ROLLING MEADOWS/ BULL HILL LETTER OF INTENT Sketch Plan

January 18, 2023 (REV1)

V_2 Letter of Intent.pdf Markup Summary

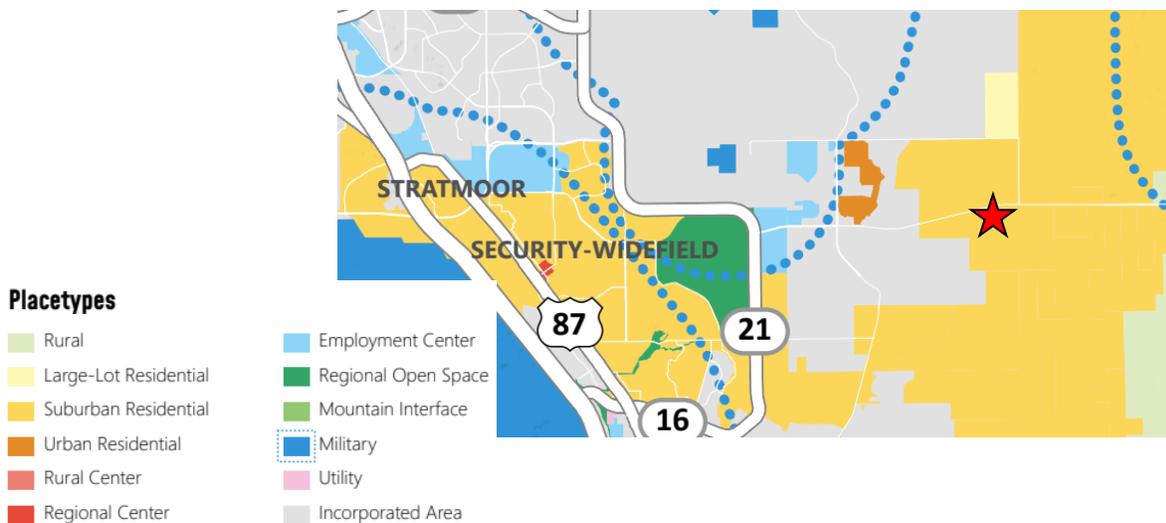
Sketch Plan Area (I added this because its still not clear that this is one sketch plan not 2- the acreages are not adding up)
